Subject: Duke Energy Corporation
Oconee Nuclear Station - Units 1, 2, and 3
Docket Nos. 50-269, 50-270, and 50-287

Revisions to Topical Report DPC-NE-3003 In Support of
Steam Generator Replacement
Response to NRC Staff Request for Additional
Information

RESPONSE TO REQUEST FOR ADDITIONAL INFORMATION
QUESTION 13

DPC-NE-3003 Revision 1 “Mass and Energy Release and Containment Response Methodology”

FIGURE 13.1
Reactor Building Temperature

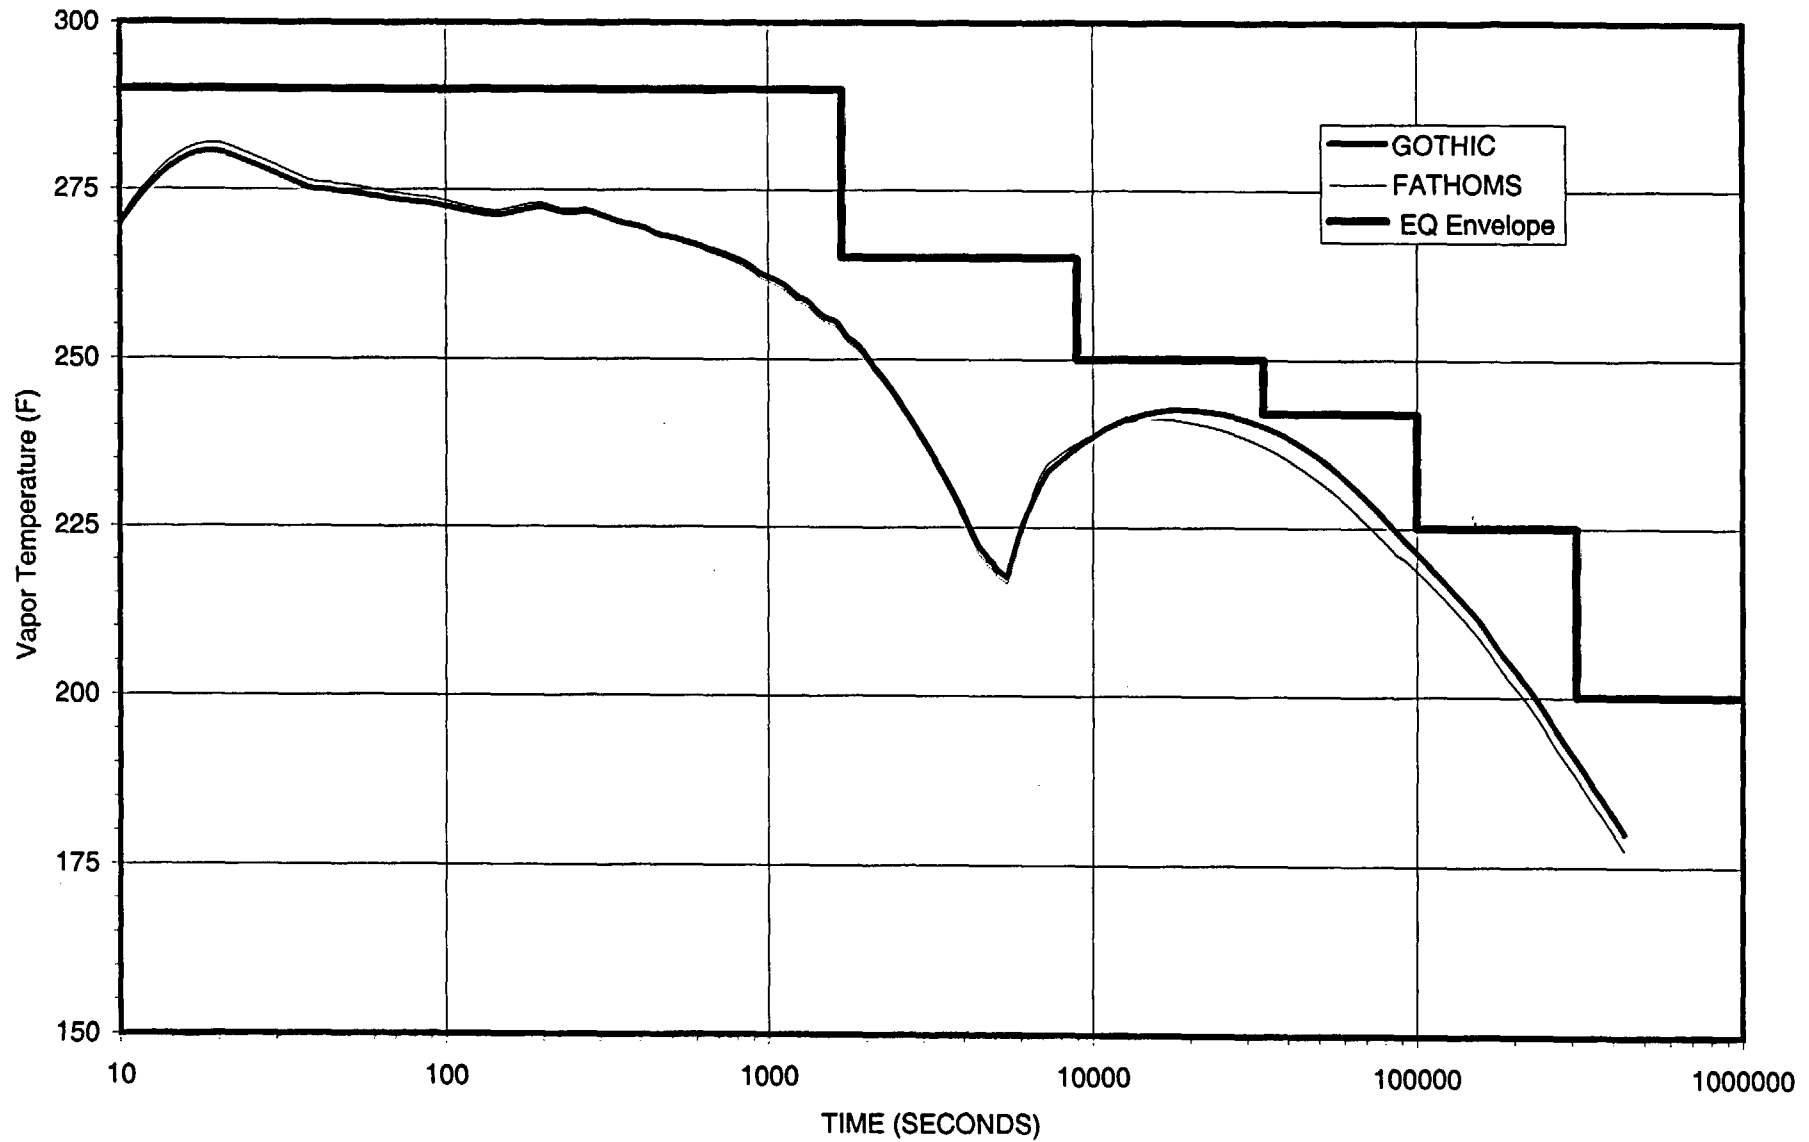
13. Provide a temperature envelope curve for EQ purposes calculated with GOTHIC and with FATHOMS. Discuss the differences in EQ envelopes calculated with FATHOMS and GOTHIC due to the different models in the two codes, especially those models which affect moisture in the atmosphere.

Figure 13.1 shows the predicted containment vapor temperature trends for the GOTHIC and FATHOMS analyses, overlaid with the EQ envelope. It is noted that this is an updated version of the EQ envelope shown in Figure 6.3-4 of DPC-NE-3003. There is excellent agreement between the FATHOMS and GOTHIC analyses for the Reactor Building vapor temperature trend. The GOTHIC analysis shows a slightly higher vapor temperature, exceeding the FATHOMS result by about 3°F at ten hours into the event.
